ADDENDUM

NO. 2

PROJECT NAME: New Operations Building

ADDENDUM DATE: Thursday, January 29, 2026

1 PLUMBING FLOOR PLAN - LEVEL 1 - AREA D - WAREHOUSE
SCALE= 1/8" = 1'-0"
TRUE

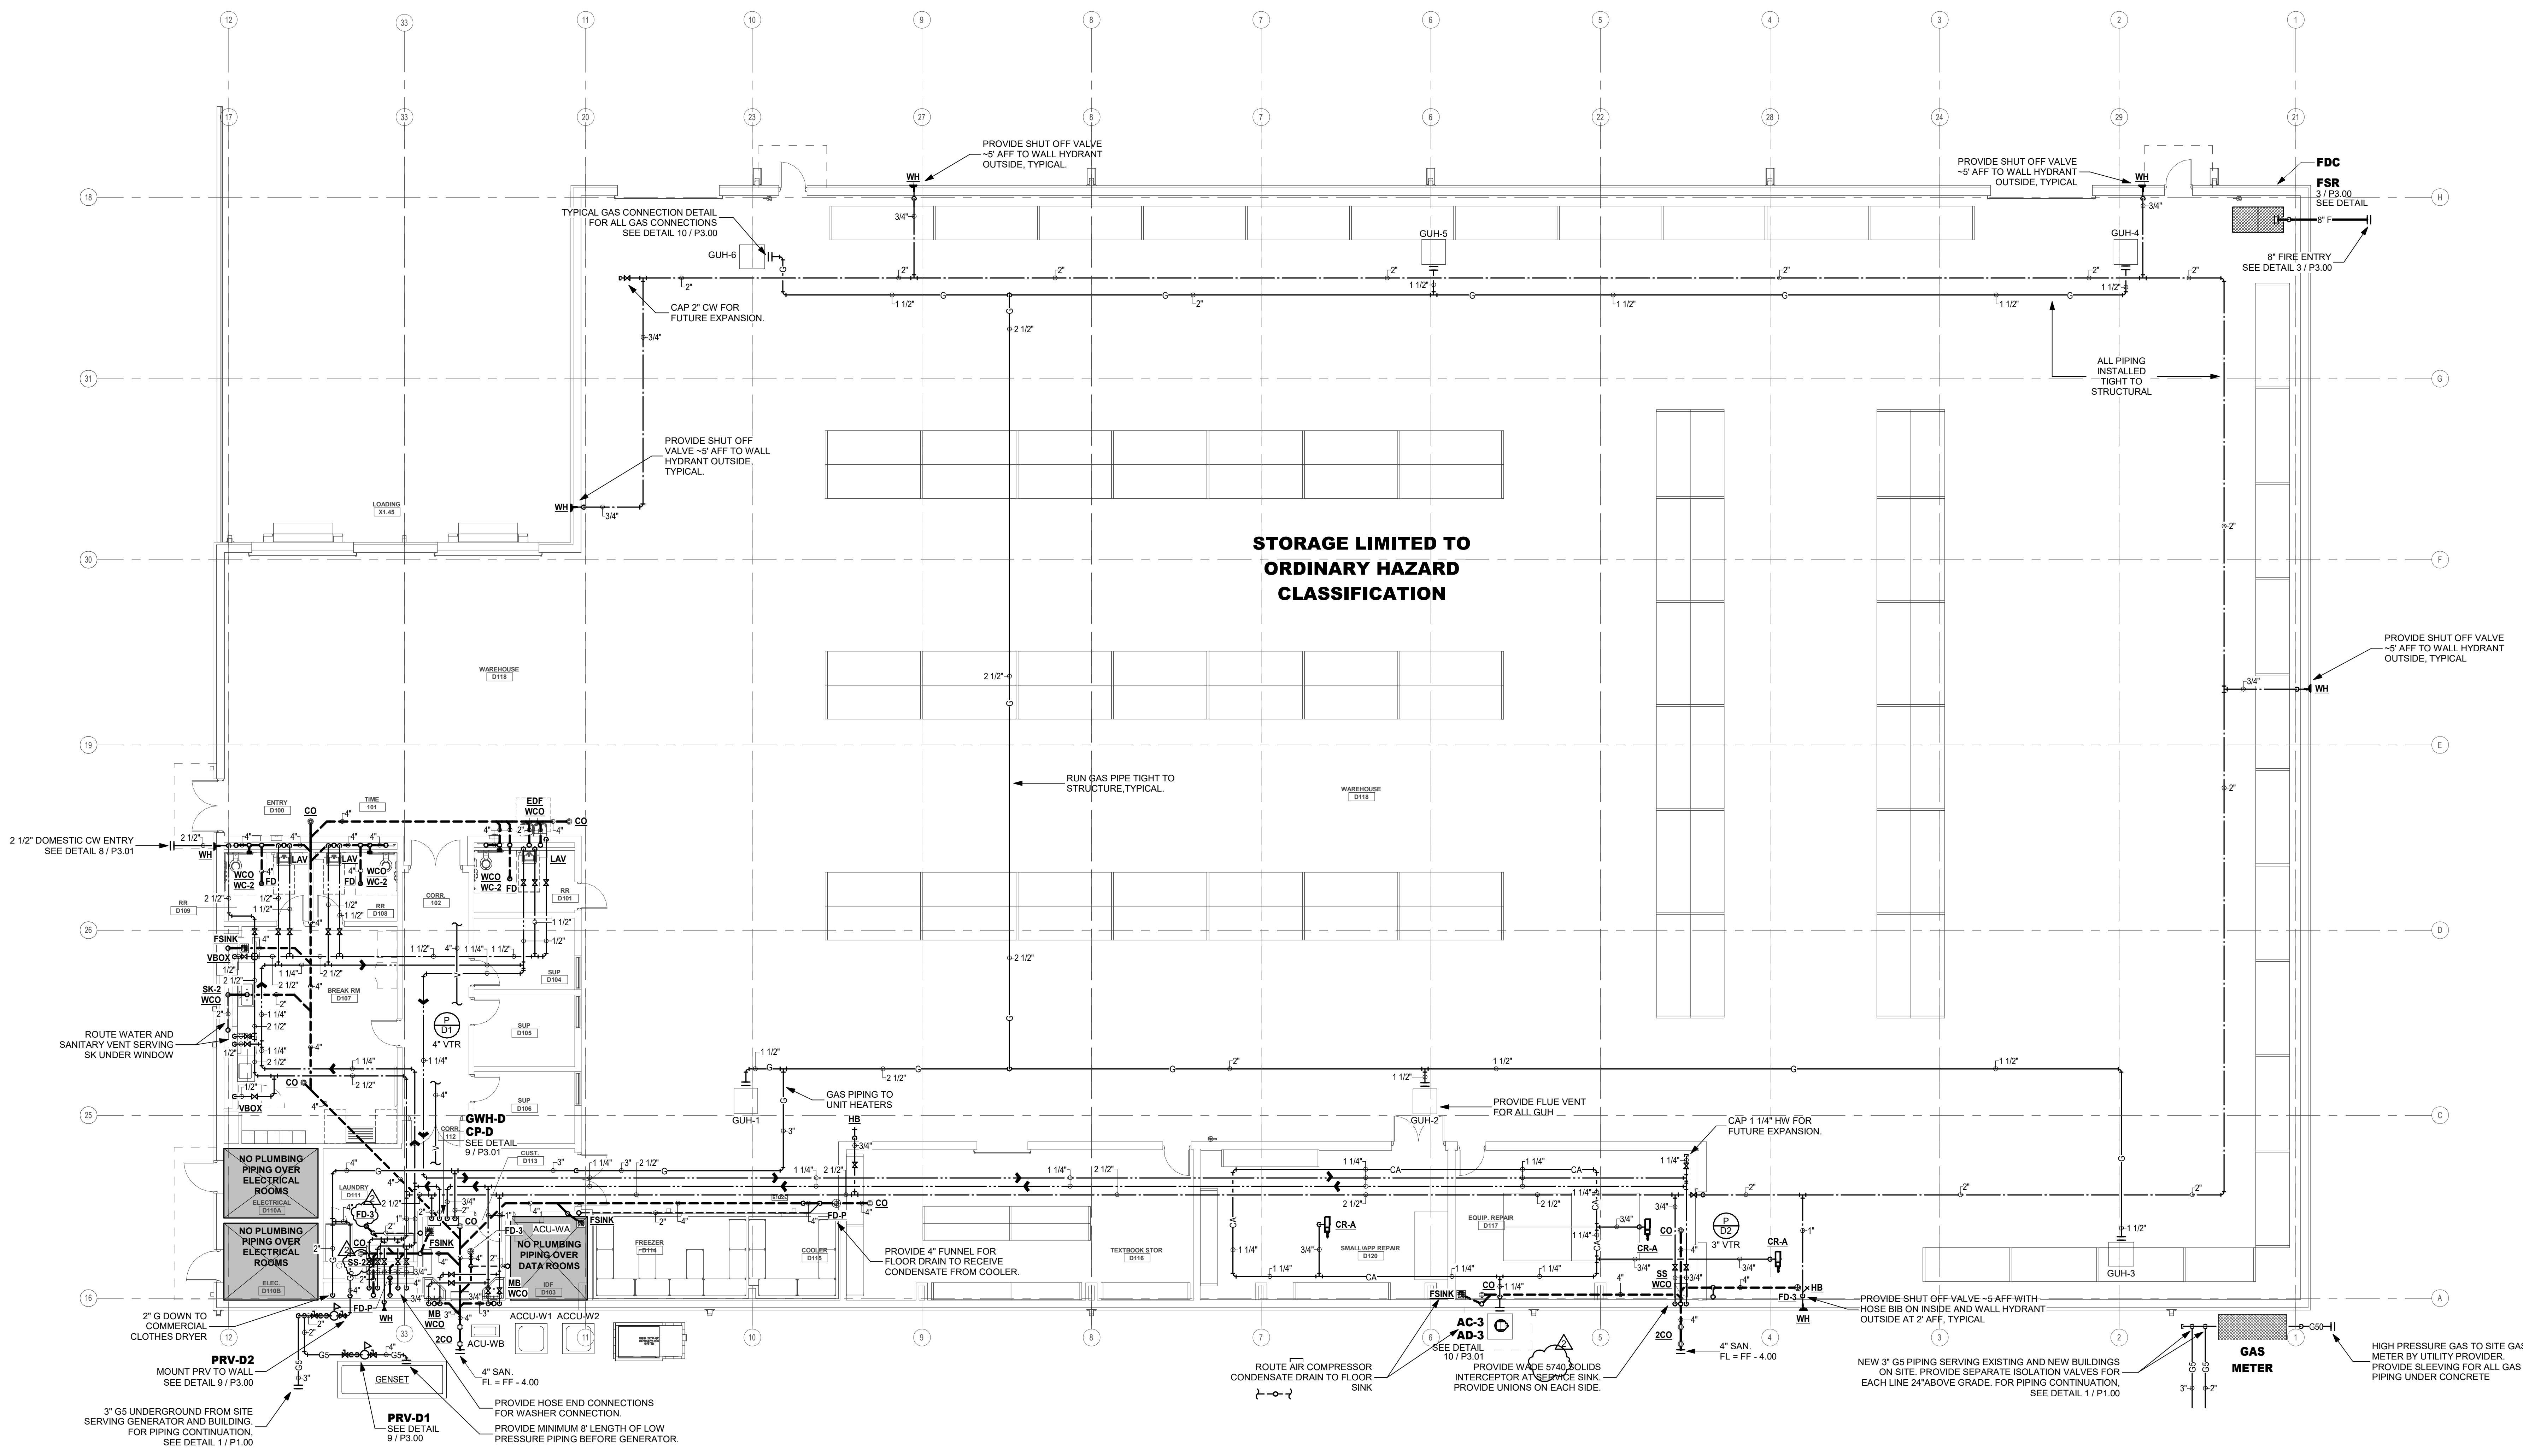
AD No 2, Plumb. Item 9: To the Drawings, Sheet P1.04, "PLUMBING FLOOR PLAN – LEVEL 1 – AREA D – WAREHOUSE,"

- 1) Removed note regarding solid interceptor, and changed fixture tag to SS-2 to indicate the interceptor.
- 2) Changed Floor drain type in laundry to be FD-3
- 3) Corrected model numbers for the solid interceptors in the shop sinks.
